**Attachment No. 7**  
**Item No.: 18A-RW-01**

## NCUTCD Proposal for Changes to the Manual on Uniform Traffic Control Devices

<b>TECHNICAL COMMITTEE:</b>	Regulatory and Warning Signs Technical Committee
<b>ITEM NUMBER:</b>	18A-RW-01
<b>TOPIC:</b>	R1-5 Series Signs – Multi-lane use vs Single Lane Use
<b>ORIGIN OF REQUEST:</b>	RWSTC Task force. Tom Heydel RWSTC (chair), Scott Kuznicki, Ross Oyen, Charles Meyer
<b>AFFECTED SECTIONS OF MUTCD:</b>	Section 2B.11 (Yield Here to Pedestrians Signs and Stop Here For Pedestrian Signs (R1-5 series))

105 **Figure 2B-2 Unsignalized Pedestrian Crosswalk Signs**

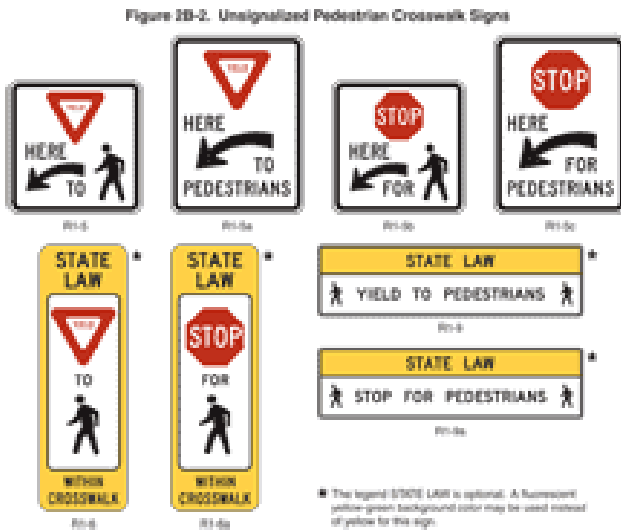
67 **Standard:**  
68 **01 Yield Here To (Stop Here For) Pedestrians (R1-5, R1-5a, R1-5b, or R1-5c) signs (see**  
69 **Figure 2B-2) shall be used if yield (stop) lines are used in advance of a marked crosswalk**  
70 **that crosses an uncontrolled ~~multi-lane~~ approach. The Stop Here for Pedestrians signs shall**  
71 **only be used where the law specifically requires that a driver must stop for a pedestrian in**  
72 **a crosswalk. ~~The legend STATE LAW may be displayed at the top of the R1-5, R1-5a, R1-~~**  
73 **~~5b, and R1-5c signs, if applicable.~~ (approved by Council 6-26-2014)**

82 04 Yield Here To (Stop Here For) Pedestrians signs may be used in advance of a crosswalk that  
 83 crosses an uncontrolled multi-lane approach to indicate to road users where to yield (stop) even  
 84 if yield (stop) lines are not used.

107 **Table 2B-1 – Add sign size for single lane for the R1-5, R1-5a, R1-5b, and R1-5c signs (36 x**  
 108 **36)**
